Document Number : IB-24-17

Title : Removal of the Tapes for LCD FFC Cable and LNO in InBody270

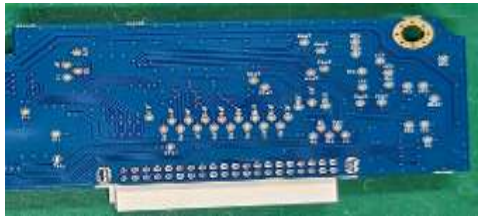
The Insulation Tape in the back of the LNO Board and the EMI tape of the LCD FFC Cable have been removed due to the improvement of LNO6 Board EMC.

Before	After
